## Wisconsin Department of Transportation

**Proposal #18: 1130-64-76, WISC 2024306**  
**Appleton – De Pere**  
**Northland/STH 15 Intchg B440315/16**  
**IH 041**  
**Outagamie County**

**1130-64-81, WISC 2024229**  
**Appleton – De Pere**  
**Capitol Drive Overpass B440317**  
**IH 041**  
**Outagamie County**

This is Addendum No. 02, which provides for the following:

## STONE DITCH CHECK

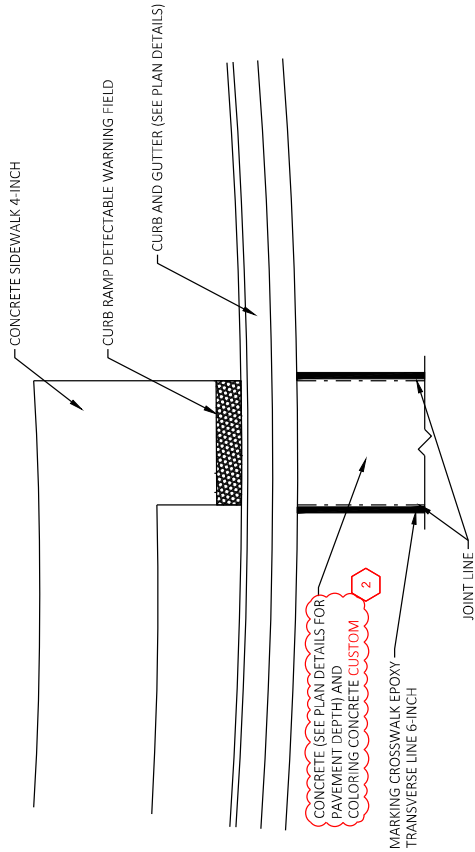
Added Plan Sheets	
Plan Sheet	Plan Sheet Title (brief description of why sheet was added)
40A	Added Stone Ditch Check construction details
520A-B	Added misc. qty. sheets for item 611.8110 Adjusting Manhole Covers

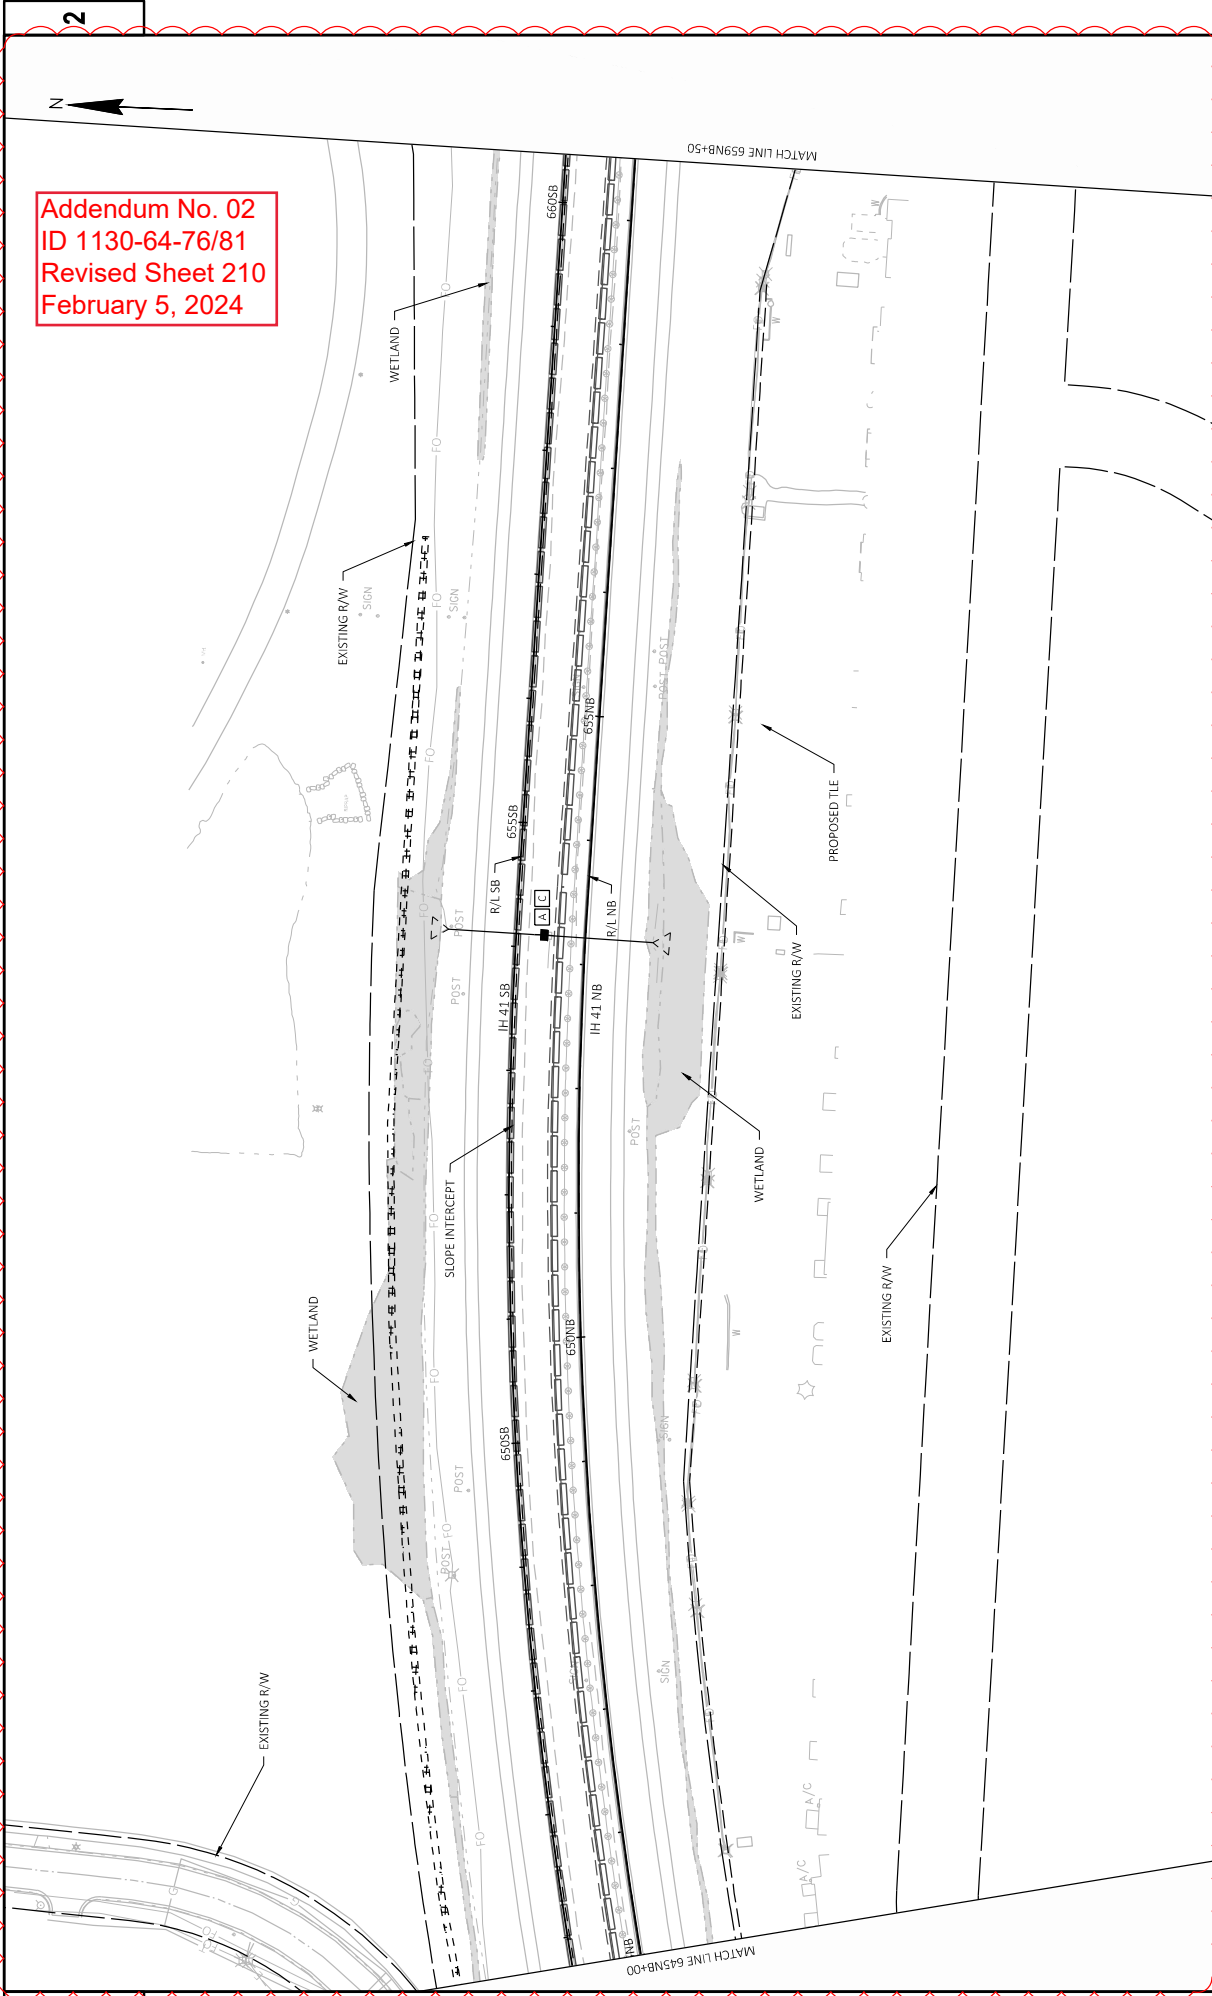
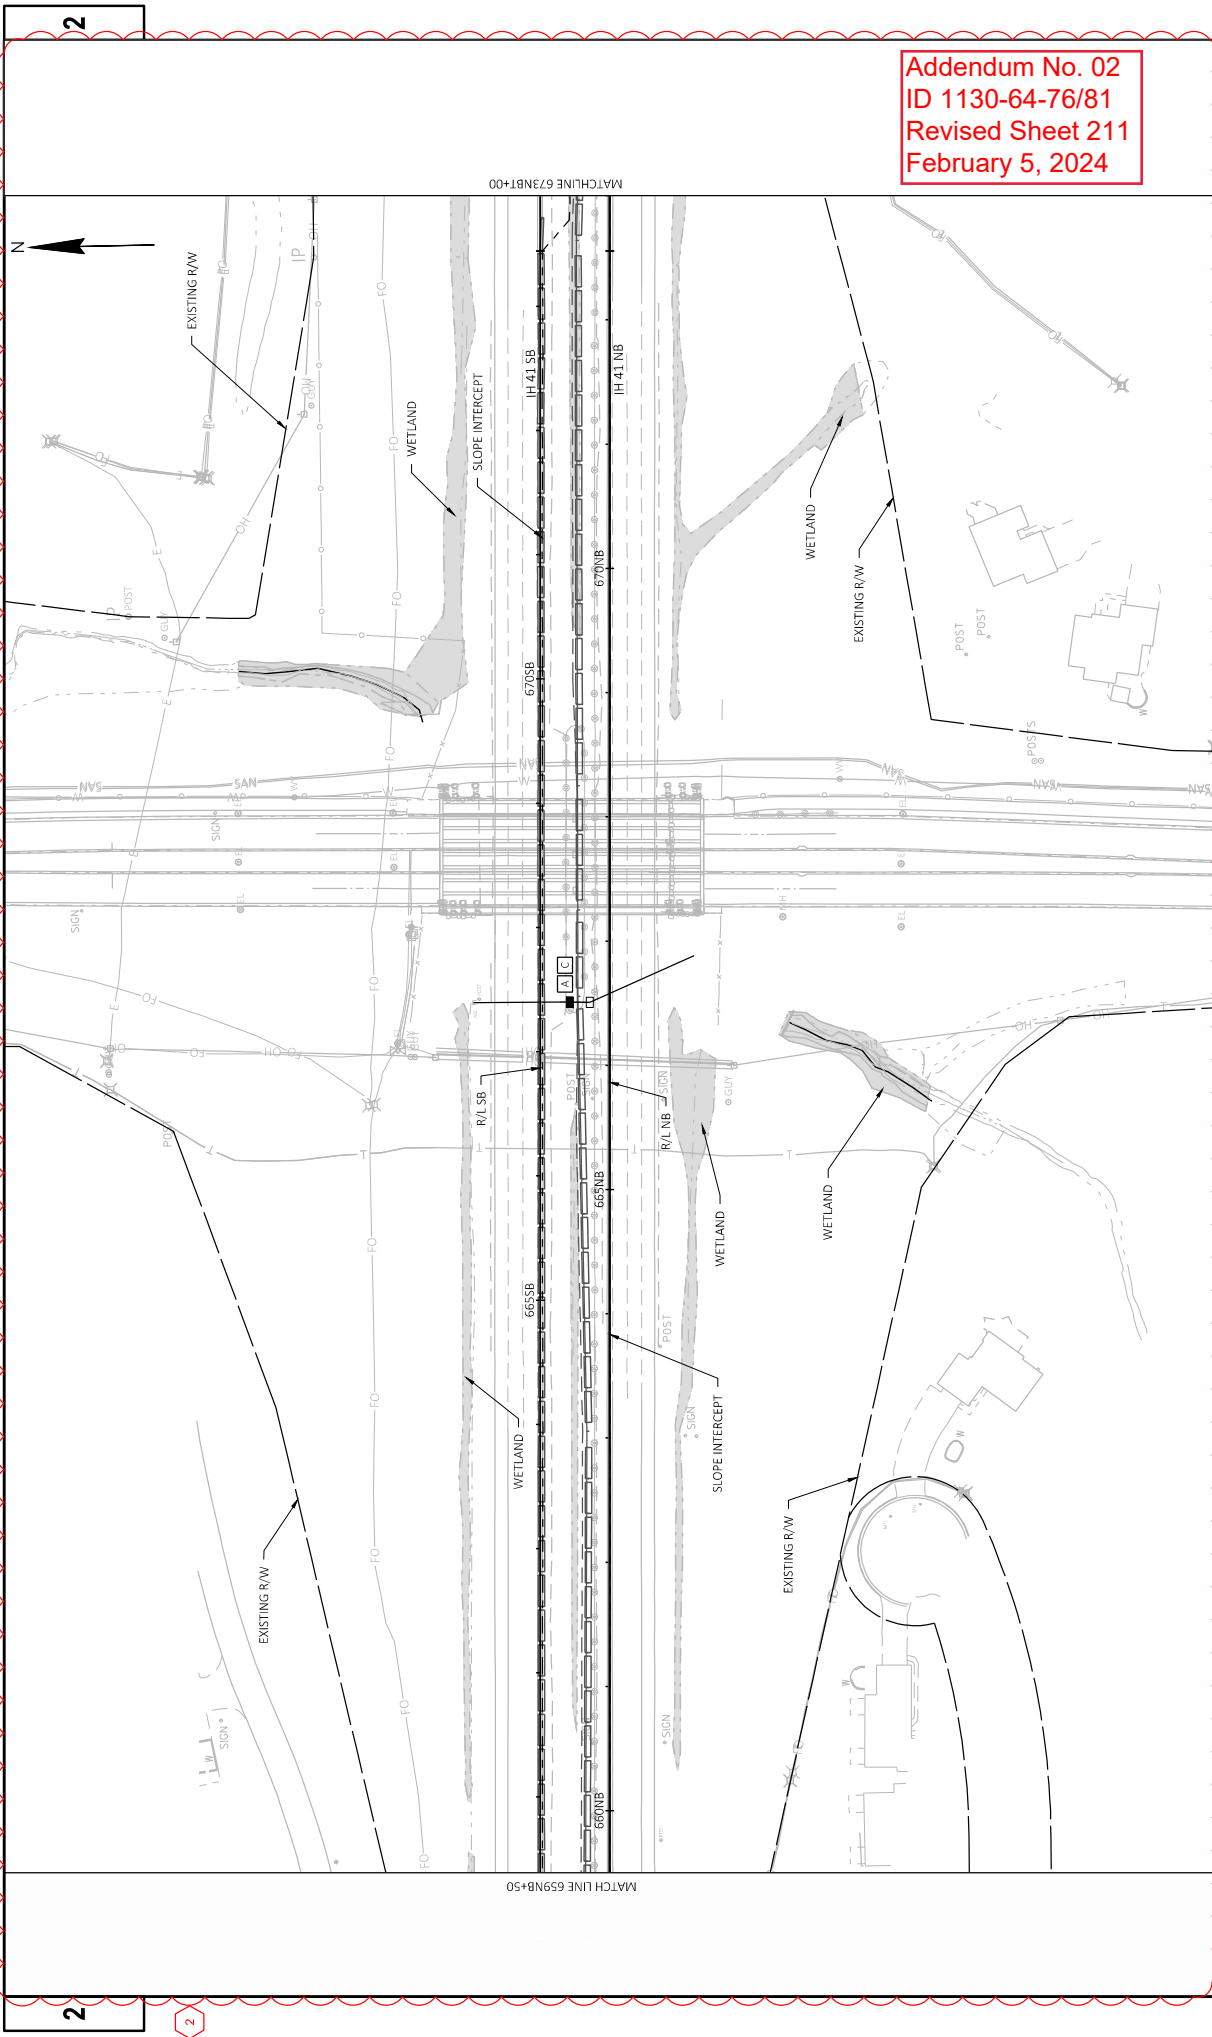
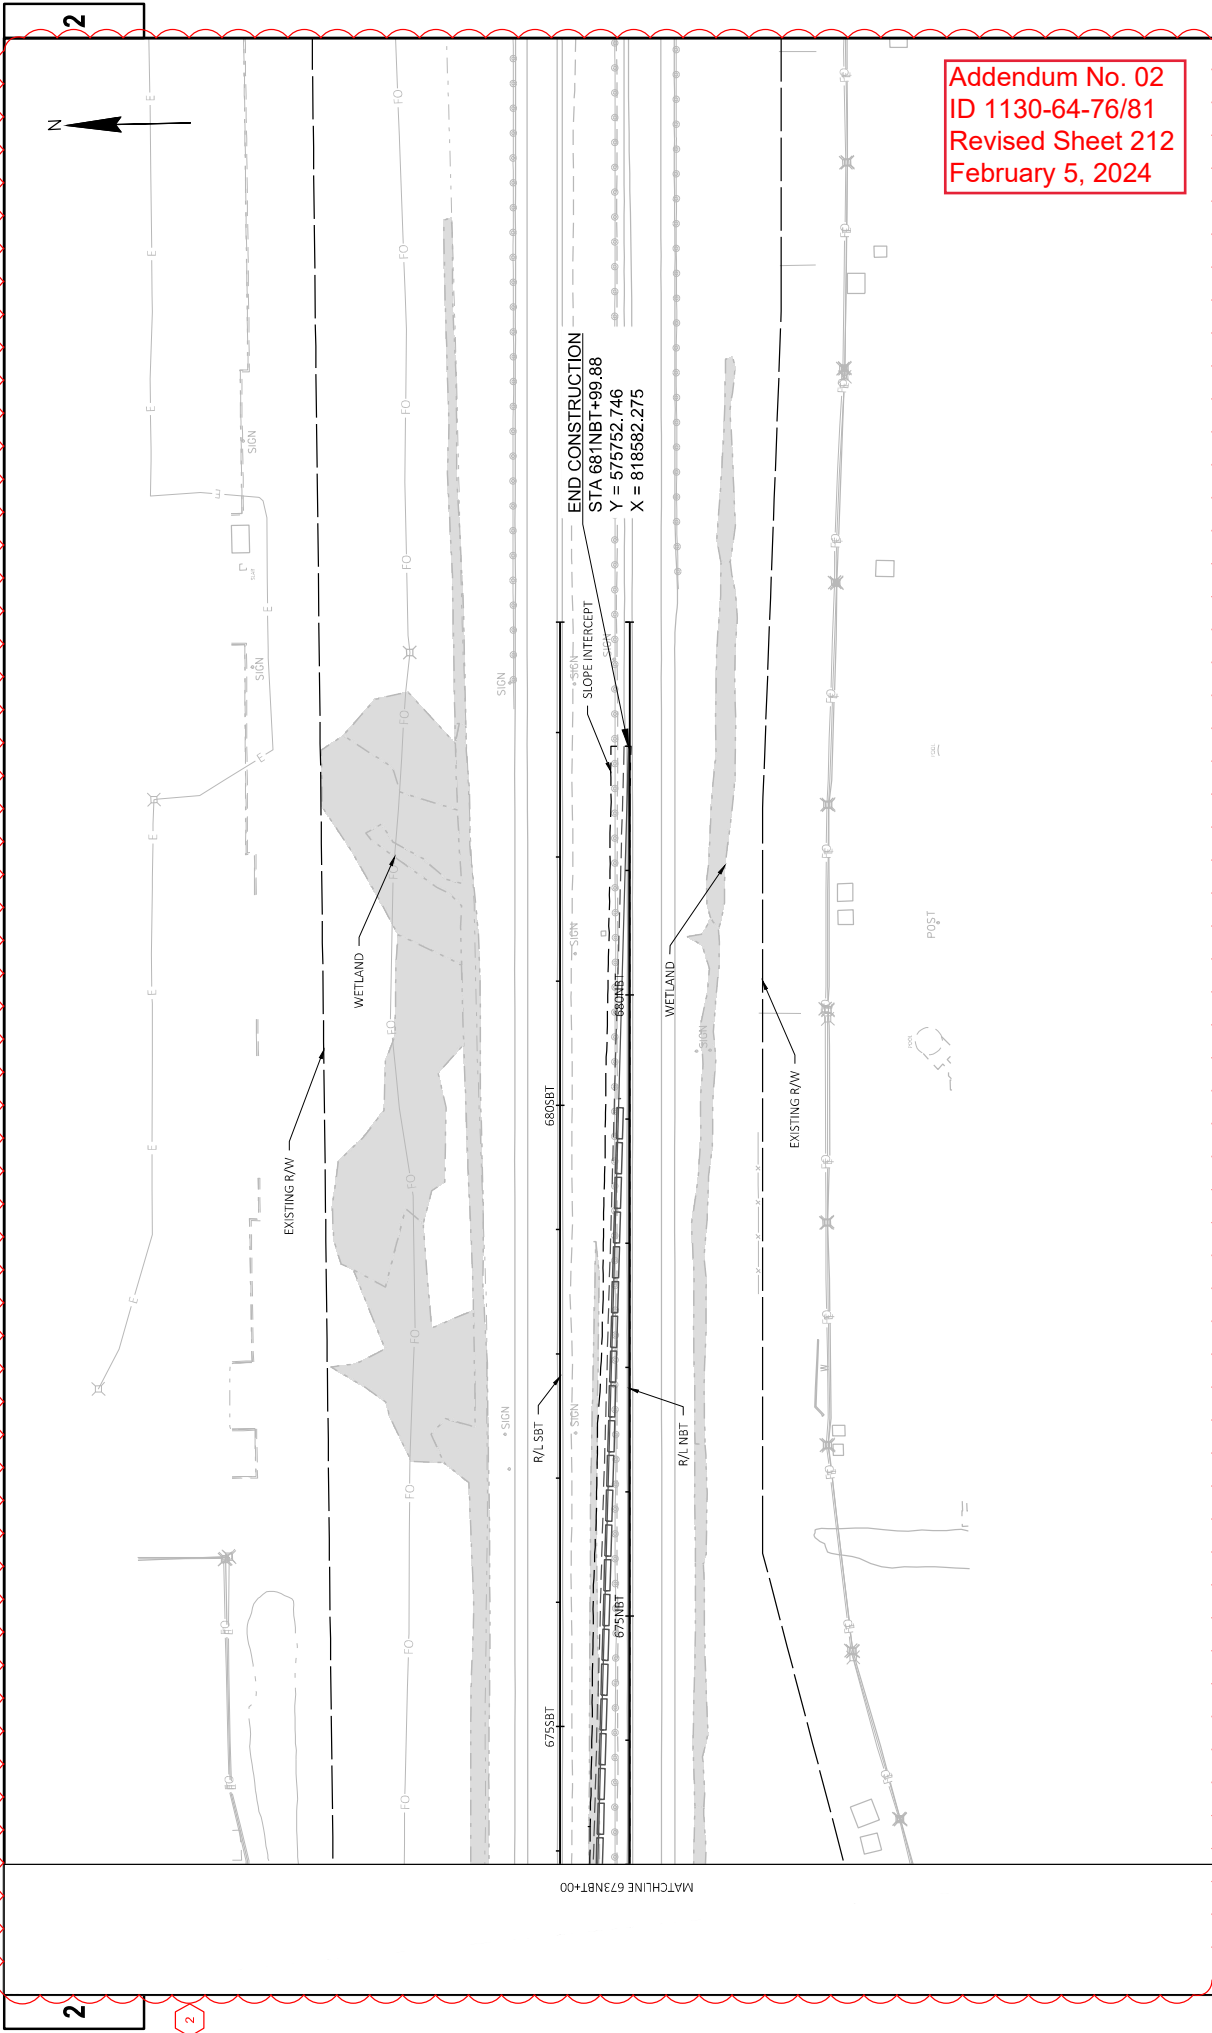
206-212	Updated proposed pavement linework to gray for clarity.
213-222	Updated proposed pavement linework to gray for clarity. Updated silt fence, temporary ditch checks and/or added stone ditch check.
227	Added STH 15 ramp D ditch grading note
237-238	Adjusted coordinates, rim elevations, and structure depth of 6472-S2.
237	Adjusted inlet coordinates of pipe between inlets 6472-S2 and 6473-S2.
240-241	Converted multiple SSRCP Class III 18-Inch pipes to Class III-A
270	Updated Lighting Plans – Bridge Abutment Conduit Detail.
427	Removed superelevation data for Ramp NLC.
455-456	Updated quantities for bid items: Riprap Medium, Riprap Heavy, Geotextile Type HR.
459-463	Updated quantities for erosion control bid items
464	Updated quantities for bid items: Fertilizer Type B, Seeding Mixture No. 30, Seed Water.
473	Updated quantities for bid item: Base Aggregate Open-Graded.
474	Removed quantities for bid item: Coloring Concrete WisDOT Red.
